**BOARD ACTION REPORT – APPEALABLE ITEM**

**Project Name:** 246 NE 6<sup>th</sup> Avenue  
**Project Location:** 246 NE 6<sup>th</sup> Avenue  
**Request:** Class V Site Plan and Architectural Elevations with two landscape Waiver requests.

### ---STAFF REPORT---

**ITEM:** **246 NE 6<sup>th</sup> Avenue (2016-182)** - Class V Site Plan and Architectural Elevations to construct a new four-story building with 3,277 sq. ft. of office on the first floor and five residential units in the upper stories with waiver requests to waive the terminal island landscape requirement and the five feet wide landscape barrier in the parking area.

1 EXTERIOR ELEVATION WEST  
SCALE: 1/8"=1'-0"

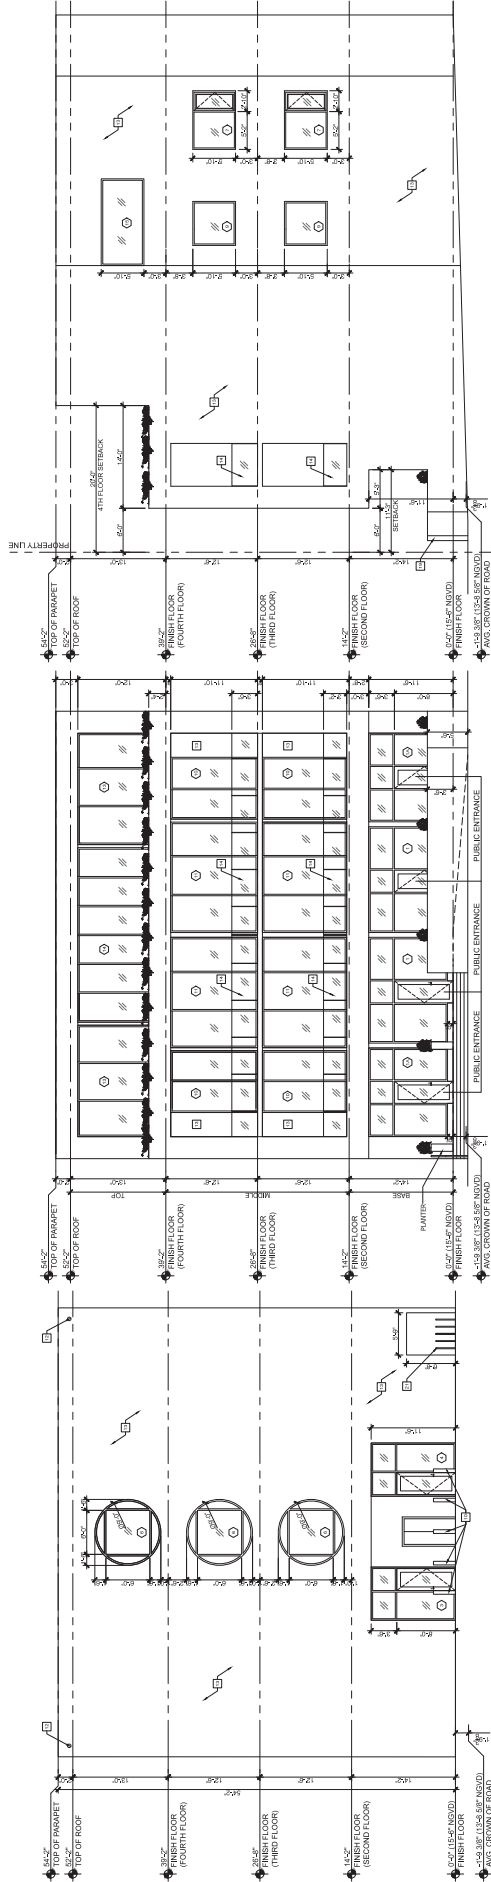
The design incorporates elements which directly contradict the CBD Architectural Design Guidelines (ADG):

- a. The ADG state, “The ratio of glass to wall emphasizes the solidity of the structure”. The ratio of glass to wall on the front façade is high and coupled with glass railings creates a transparent building façade that detracts from the solidity of the structure.
- b. The ADG state the style has a “system of punched openings vs. large expansive walls of windows.” The front façade is composed of expansive walls of windows, which is specifically called out as contrary to the style.
- c. The Characteristics listed on Sheet A-3.3 state the style has “Railings are glass, wood, or extensions of solid walls”. The guidelines actually state that, “Railings are **metal**, wood, or extensions of solid walls”. The proposed glass railings are not listed as one of the appropriate materials for the style.

Generally, the proposed architecture is more simple and stark than the guidelines demonstrate. There is no hierarchy among the masonry portions of the building; the cantilevered portion is the same thickness and mass as the base and the top, which appears incongruent with a “rational load bearing system.” Incorporation of forms to denote the building entry or reflect the building program, shade

devices, or the addition of accent materials such as wood or stone would add a layer of richness to the design that would be more consistent with the examples in the guidelines.

Pursuant to **LDR Section 4.4.13(F)(5)(a)2.**, all public entries, excluding emergency exits, shall be easily identifiable and integrated into the building architecture and use one of the frontage types in Section 4.4.13(E)(4). Each freestanding principal structure shall have a minimum of one clearly defined primary public entrance facing the street. The hardscape design denotes the access to the structure; however, the front facade demonstrates entry by simply incorporating doors within the storefront glass, which is only differentiated by a thin door frame and door handle.

Given the analysis above, staff recommends denial of the Architectural Elevations, based on findings that the front façade does not meet Standard 1, as the proposed design does not contribute to the image of the City as defined by the adopted CBD Architecture Design Guidelines by incorporating design elements (expansive glass walls with glass railings) that contradict the style, and Standard 3, as the proposed building will stand out from surrounding redevelopment as it does not contain sufficient architectural detail to be consistent with the CBD Architectural Design Guidelines (adopted, supplemental criteria)

Move denial of the Architectural Elevations for **246 NE 6<sup>th</sup> Avenue**, by adopting the findings of fact and law contained in the staff report, and finding that the request does not meets criteria set forth in 2.4.5(I)(5), Section 4.6.18(E) and Section 4.4.13 (F)(3) of the Land Development Regulations, specifically:

1. Standard 1 as the proposed design does not contribute to the image of the City as defined by the adopted CBD Architecture Design Guidelines;
2. Standard 3 as the proposed structure is not in harmony with the CBD Architectural Design Guidelines (adopted, supplemental criteria); and
3. The Masonry Modern architectural style per LDR Section 4.4.13(F)(3)(a)(6).
